## Technical Memorandum

**TO:** Mr. Alan Day, General Manager  
Brazos Valley Groundwater Conservation District

**SUBJECT:** Hydrogeologic Review of Transport Permit Applications for Mr. James Brien, Cula d’Brazos LLC, Ely Family Partnership LP, Fazzino Investments LP, RH2O LLC, Mr. Clifford A. Skiles III, and L. Wiese Moore LLC

Figure 2. Original and modified location of the modeled faults in Version 3.02 of the Central Portion of the Sparta, Queen City and Carrizo-Wilcox Aquifers GAM.

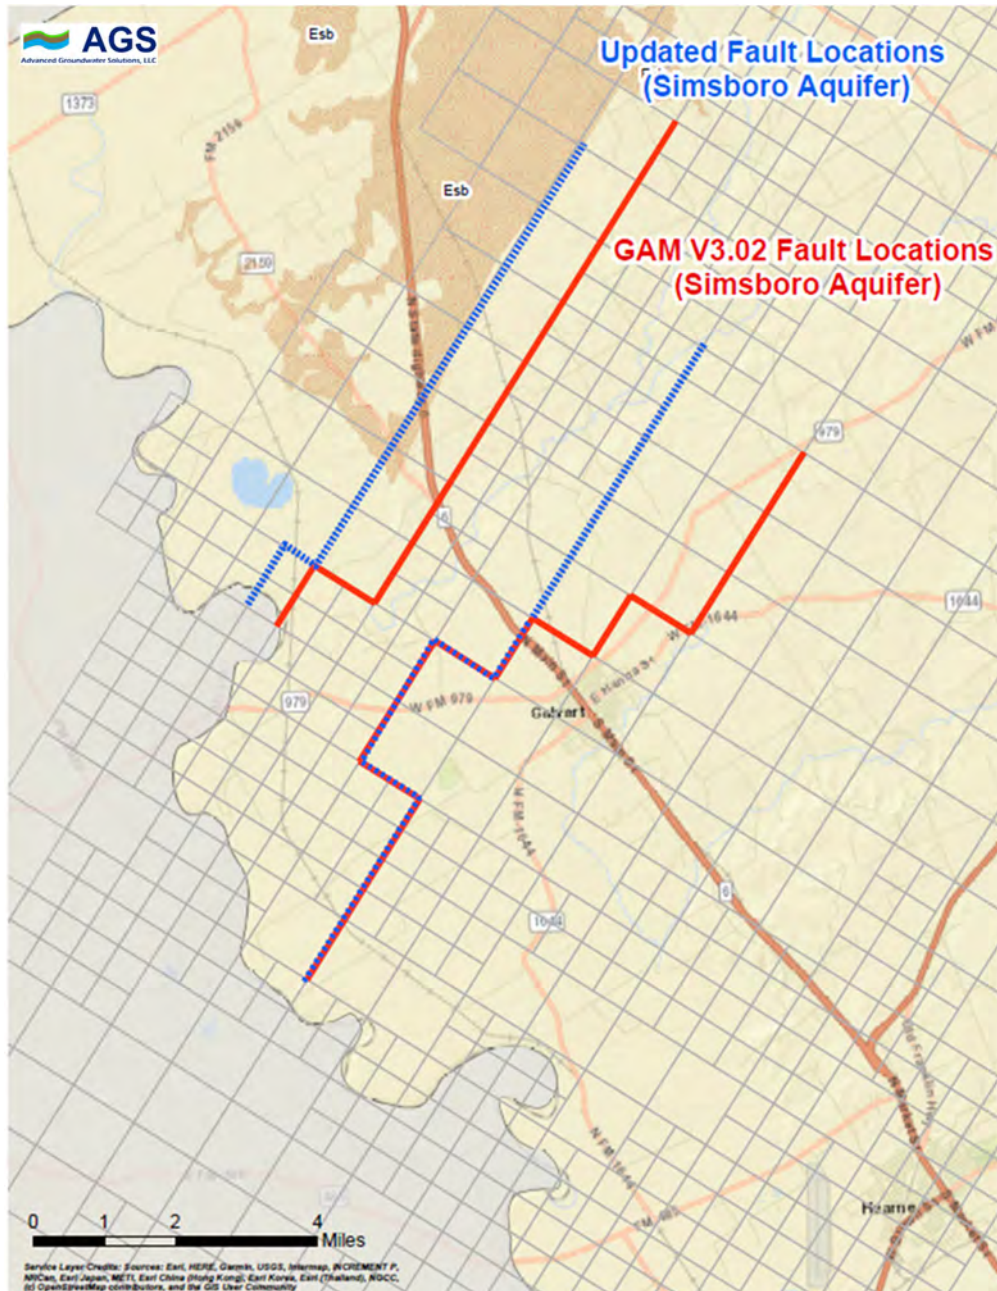
Using available geophysical logs and water level data, Ground Water Consultants LLC and AGS have been refining the location of a fault that is located north of the City of Calvert. There is a slight offset between the fault as shown in version 3.02 of the Central Portion of the Sparta, Queen City and Carrizo-Wilcox Aquifers GAM and the fault mapped using geophysical logs. The fault has been shifted slightly to the northwest by one or two model cells based on the geophysical log data. Figure 2 shows the GAM Version 3.02 fault location (red line) and the updated fault location (blue dashed line). A part of the fault that is located immediately to the north and west of Calvert from about Highway 6 back towards the southwest was not adjusted. This is shown by the overlapping red and blue dash lines on Figure 2. AGS updated the location of these faults in Version 3.02 of the Central Portion of the Sparta, Queen City and Carrizo-Wilcox Aquifers GAM (INTERA Incorporated and others, 2020).

Figure 4. AGS simulated Simsboro drawdown in 2059 from 50,000 ac-ft/yr scenario by UWBVF wells under existing transport permit (BVTP-001).

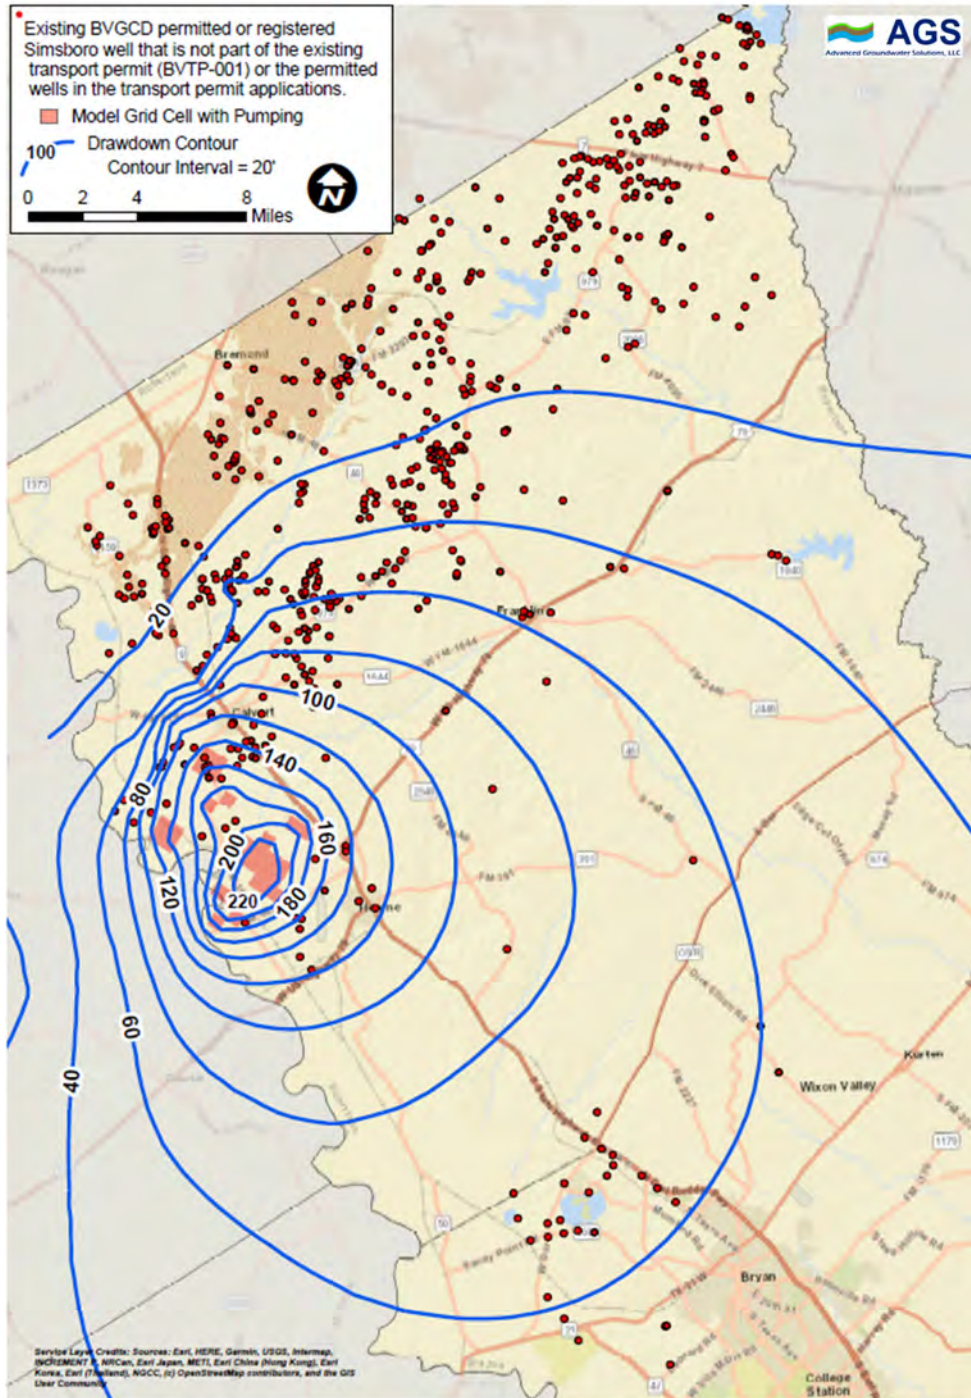
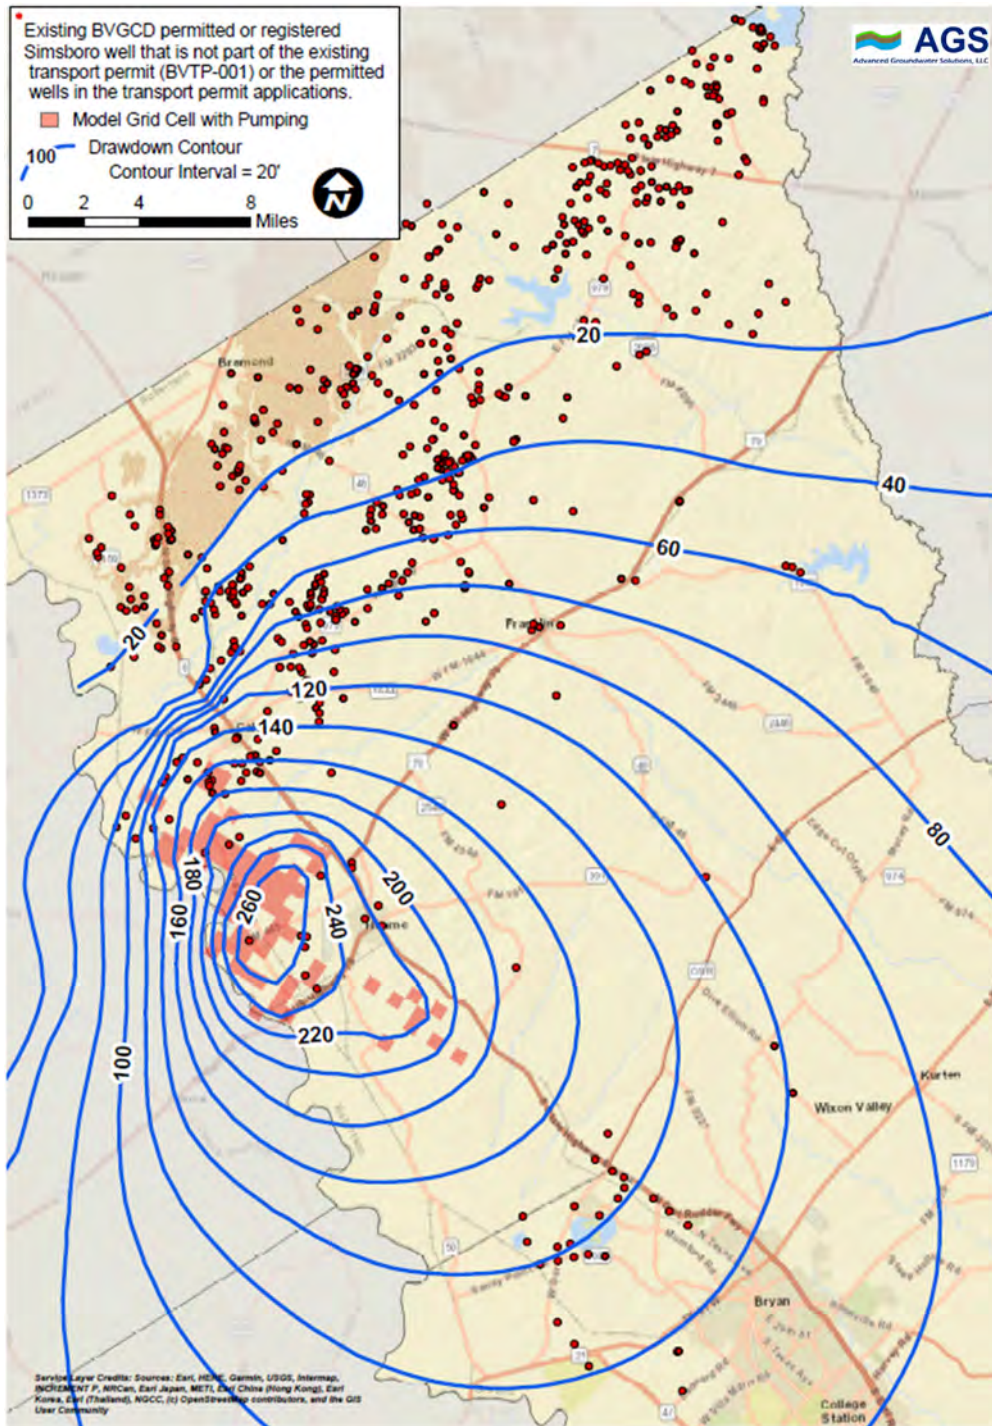
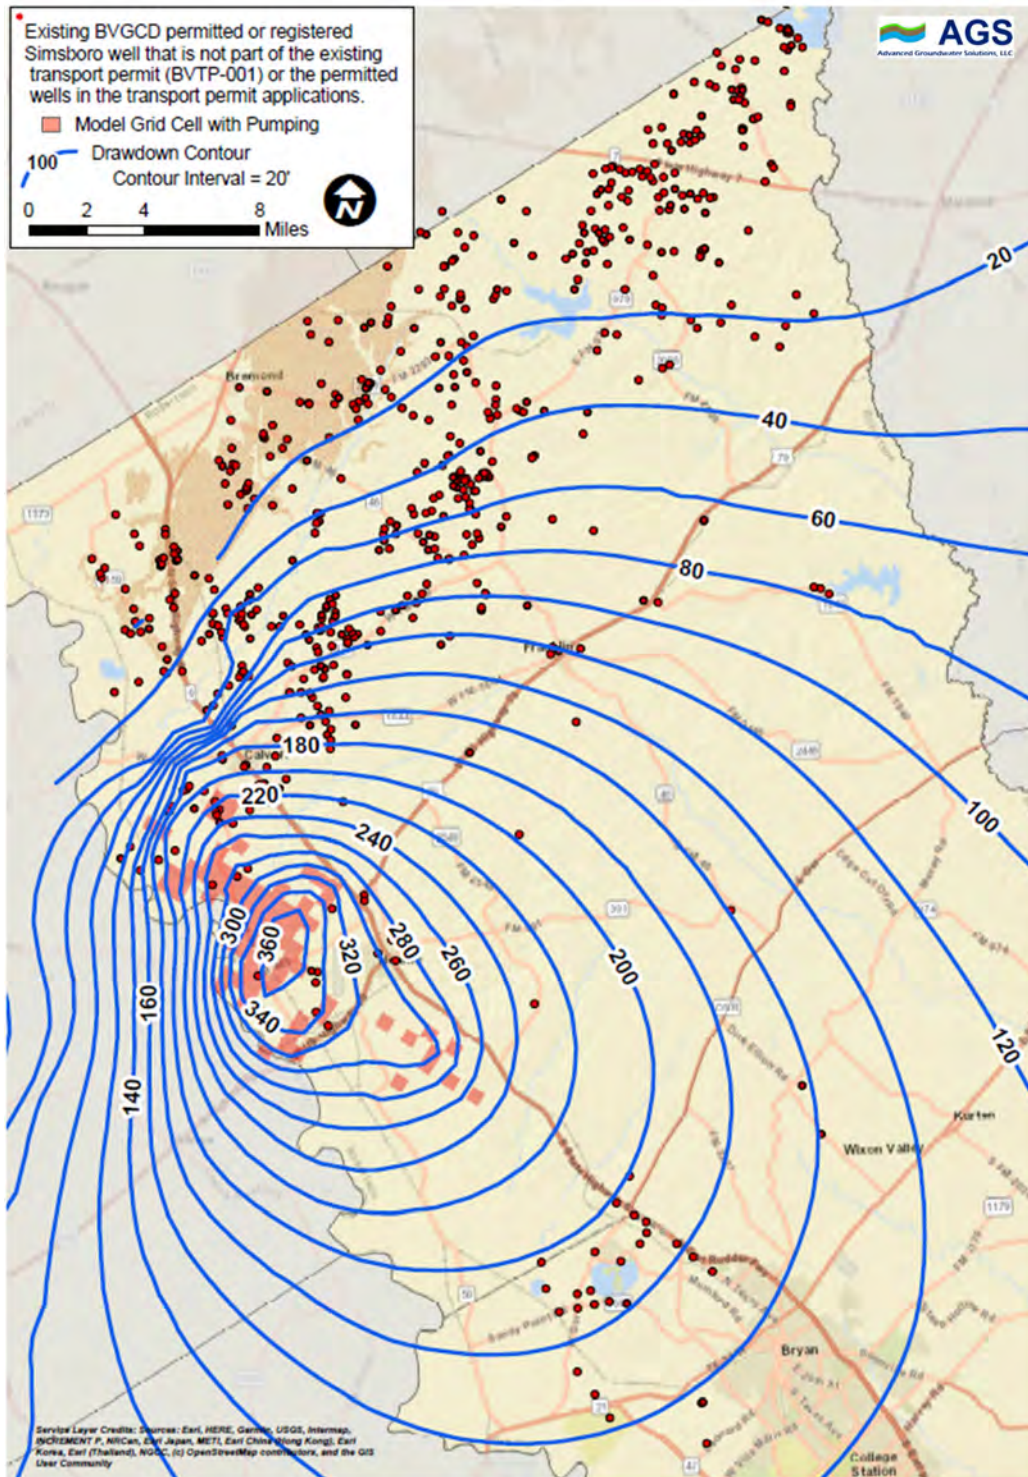
The isolated pumping effects in the Simsboro Aquifer shown in Figures 4, 5 and 6 after pumping an additional 50,000 ac-ft/yr, 75,000 ac-ft/yr and 100,000 ac-ft/yr for 30-years, respectively, show increased drawdown near the UWBFV well locations and the locations of the permitted wells in the transport permit applications. The pumping effects radiate outward from the UWBFV area and decrease with distance from the UWBFV. The effects of the fault discussed early in this memorandum can be observed in the area to the north-northwest of Calvert as the drawdown difference contours appear to bunch together at south of the fault.

Figure 7. AGS simulated remaining available drawdown above the top of the Simsboro Aquifer in 2059 that results from the S-19G3 + 50,000 ac-ft/yr pumping scenario.

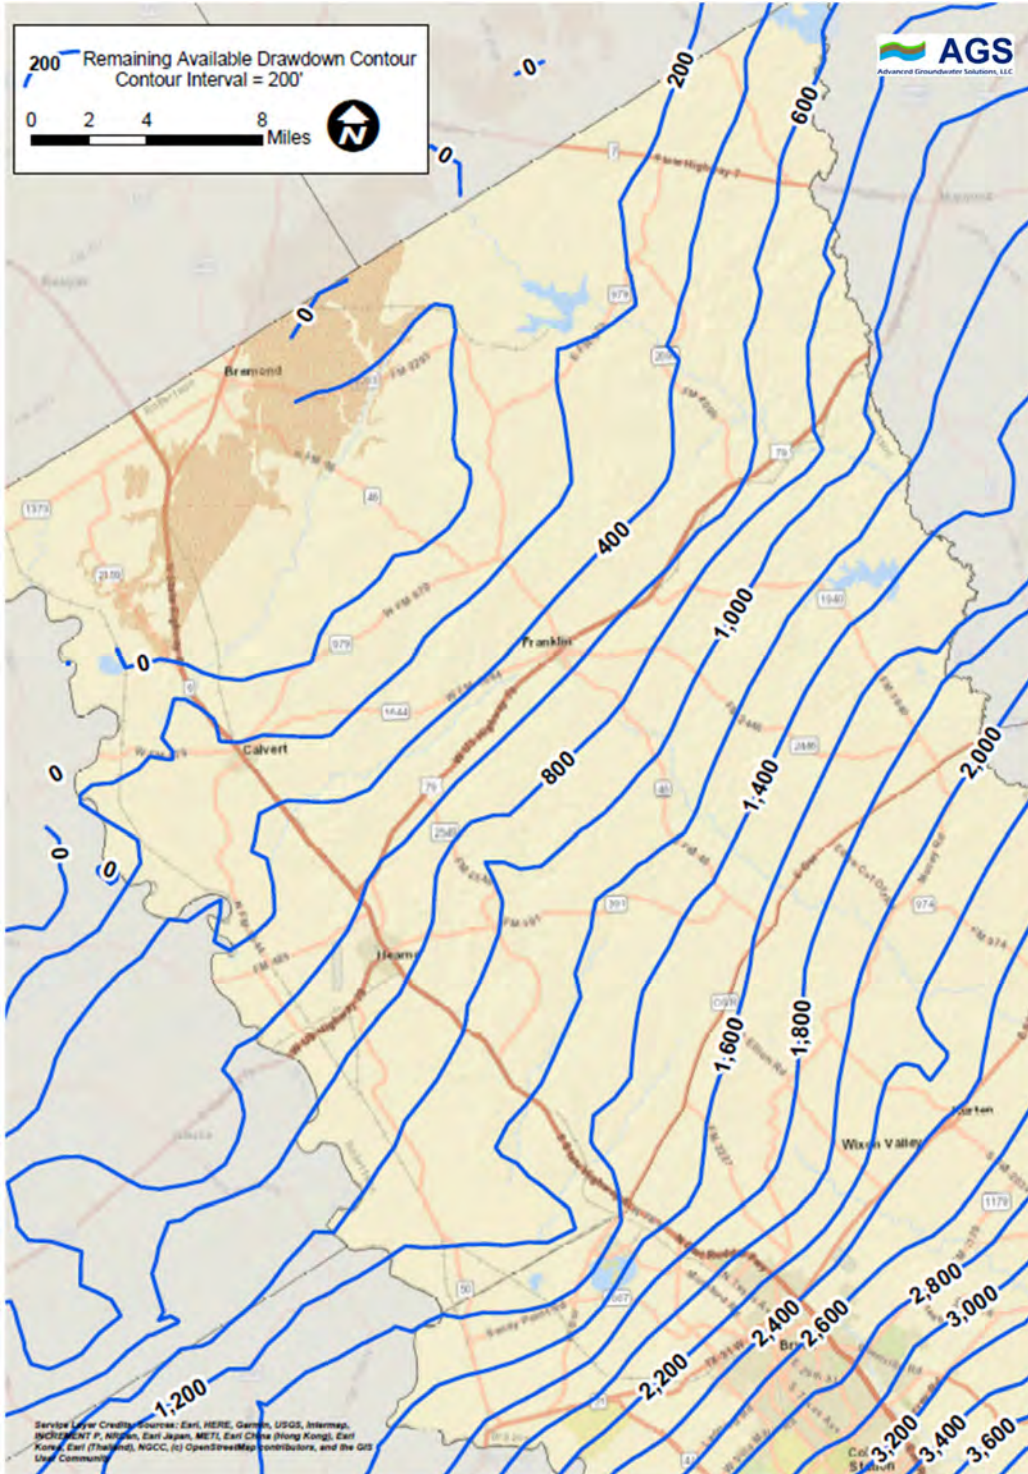
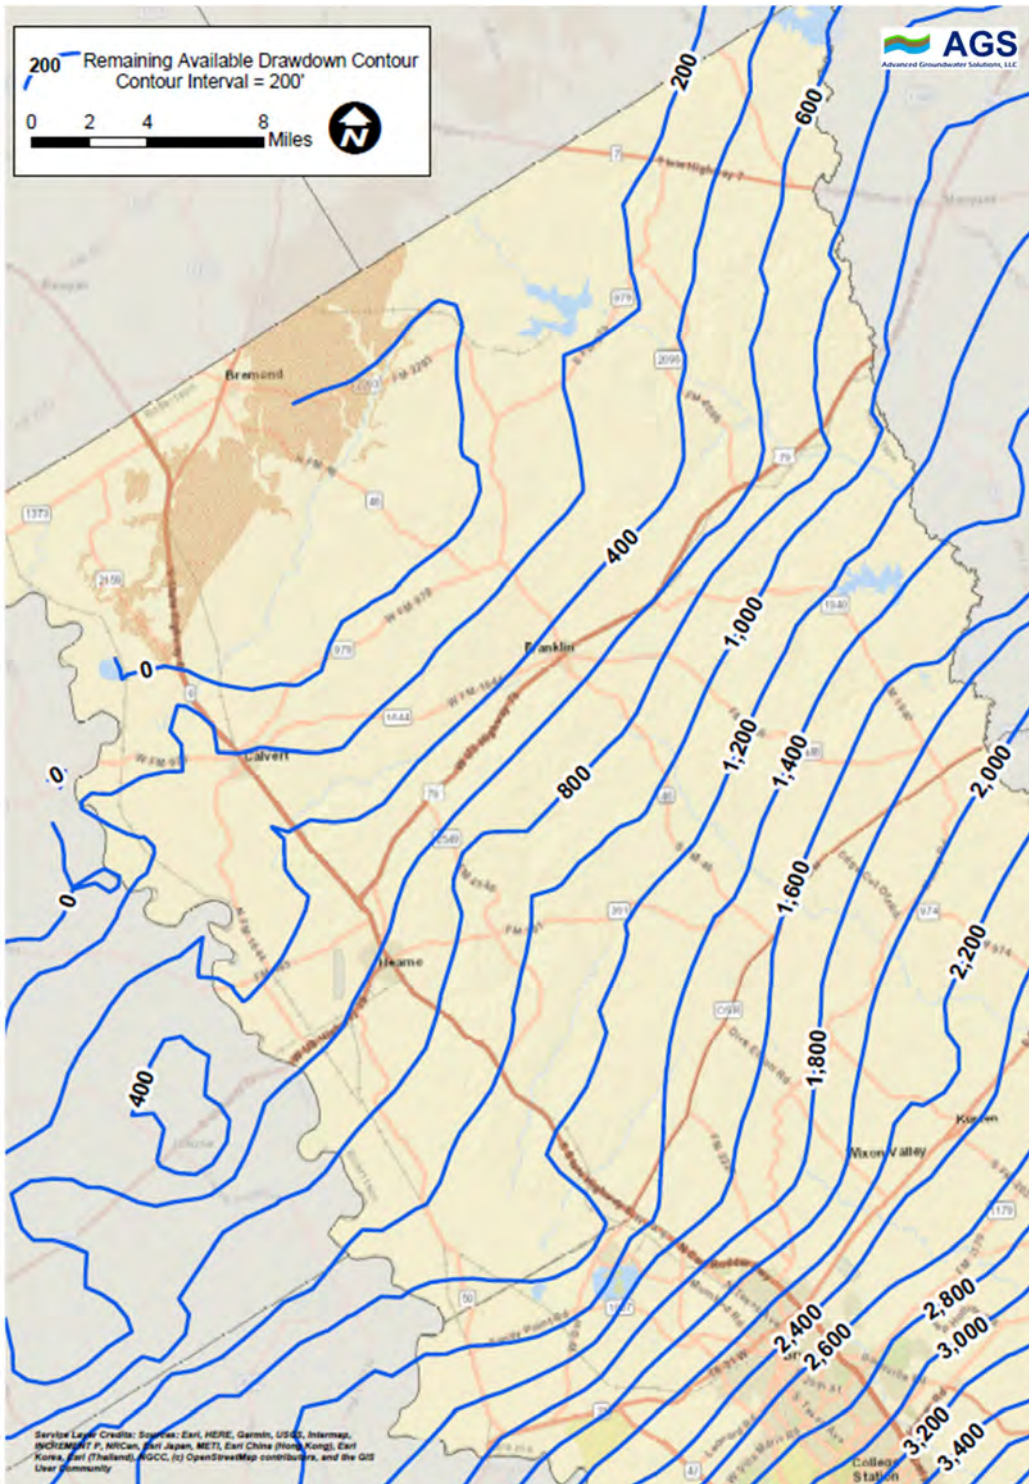
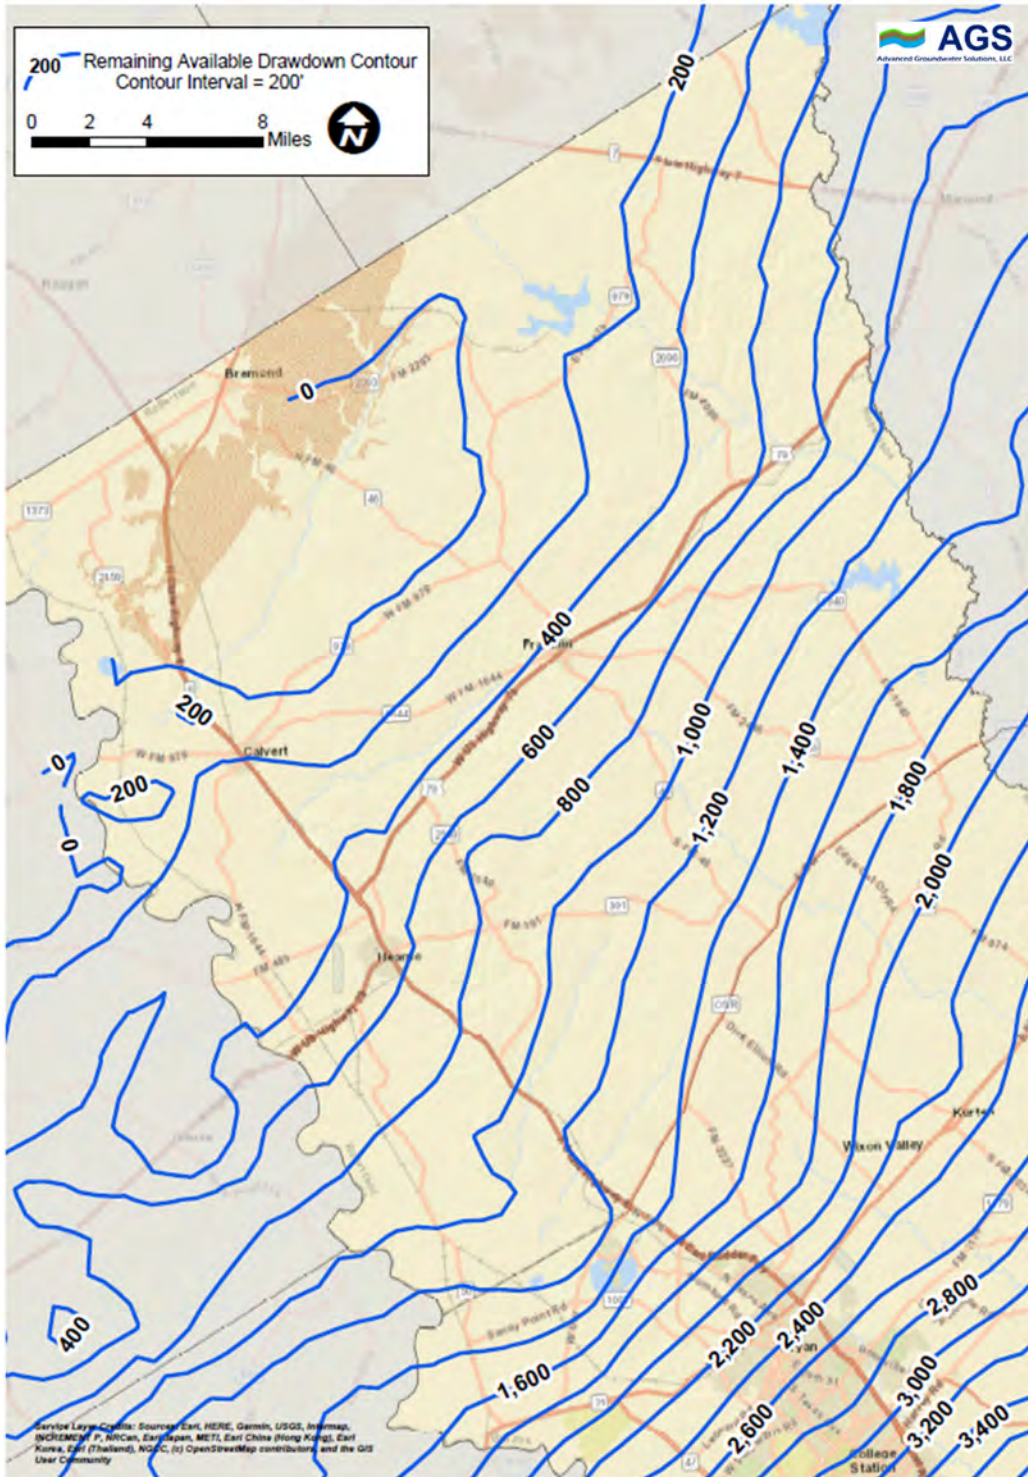
The model simulations show that the simulated remaining available drawdown remains above the top of the Simsboro Aquifer in the three transport scenarios.
